THE PORT AUTHORITY OF NY & NJ

ADDENDUM # 1

To prospective Bidder(s) on Bid # **36208** for Aircraft Runway Rated Concrete Handholds 4ft X 4ft X 4ft, Newark Liberty International Airport. Furnish and Deliver In Accordance with Specifications and Drawing.

**TYPICAL DUCTBANK AND
 CONDUIT DETAILS**

CONDUIT ENTRY DETAIL AT MANHOLE OR HANDHOLE
 NTS

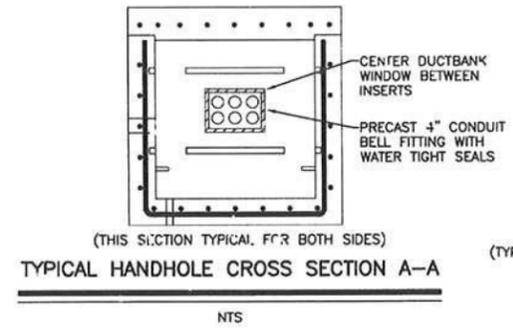
Question # 1	Section A-A on drawing #E968 indicates that duct windows with bell fittings are required in the handhole walls. The elevation in the "Typical Detail Of Window & Siding Connection For Duct" shows the same requirement, but Section B-B in the same typical detail implies an oversized hole or knockout is required in the handhole walls with joint material and mastic and concrete encasement. Furthermore, note 18 on the same drawing states all four walls are to contain duct windows utilizing bell sizes per drawing E969. Is the bidder/vendor to provide holes (knockouts) in all four walls, or bell fittings cast in all four walls. If the requirement is to cast in the bell fittings in all four walls, provide the referenced drawing E969, or provide exact details of the size and quantity of bell fittings that are required in each of the four walls in each of the total 87 units that are required to be supplied in this solicitation

Answer # 1	Bidders are instructed to review attached drawing #E969 date 11/08/2013 and the handholes should be provided with the conduit bell fittings casted in the walls, 6 way – 4” bell fittings in walls: 0° and 180° (opposite walls) and 4 way – 2” bell fittings in walls: 90° and 270° (opposite walls).
